S E R V I C E N O T E

1661E - 102 Channel Color Logic Analyzer

New Threshold Accuracy Field Calibration Procedure

Page 2 Service Note 1661E-01

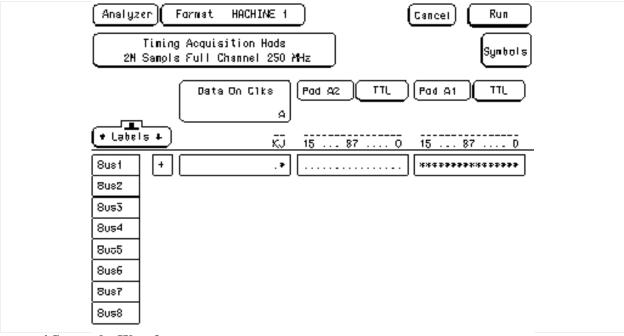
ADD the following steps to "Set up the logic analyzer" on page 3-10 of the 1660E,ES,EP-Series service manual:

3 Set up the Format menu.

- a. Press the Format key.
- b. Move the cursor over the Pod A1 channel selection field.

Press the Clear Entry button until all channels are assigned (all '*'), then press Done.
- c. Move the cursor over the Data on Clocks channel selection field, then press Select. Rotate the RPG knob to move the channel selector to the channel indicated in the following table, then press Select. Press Done.

4 Set up the Waveform menu.

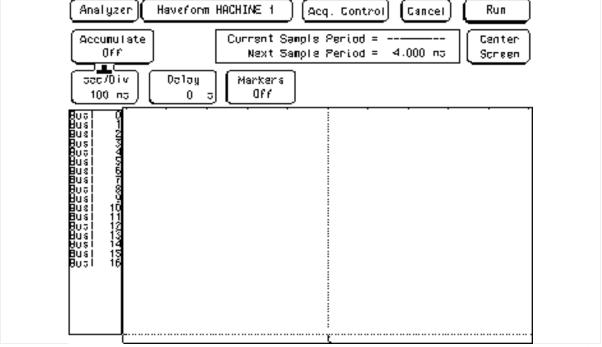
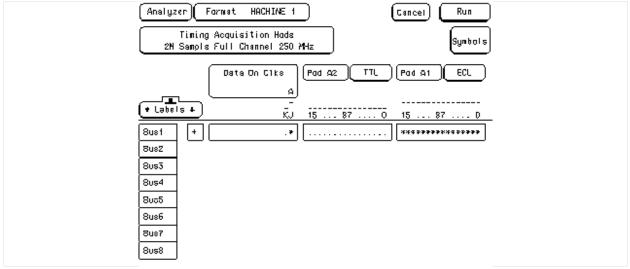
- a. Press the Waveform key.
- b. In the Waveform menu, move the cursor to the pod/channel selection field, then press Select.

In the pop-up menu, select Delete All, then select Continue.

c. Again press Select. At the pop-up menu, select Insert, then select Bus1, then select Sequential.

2 Test the high-to-low transition.

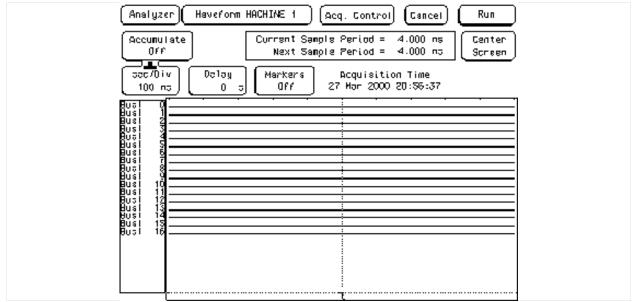
REPLACE pages 3-11 thru 3-17 with the following steps:

Test the ECL Threshold

- a. On the DC power source, enter -1.438 V.
- b. On the multimeter, verify that the DC voltage is -1.439 V +0 mV, or -2 mV. Adjust the DC power source voltage output if necessary.
- c. On the logic analyzer, press Run. The display should show all channels at a logic "0".
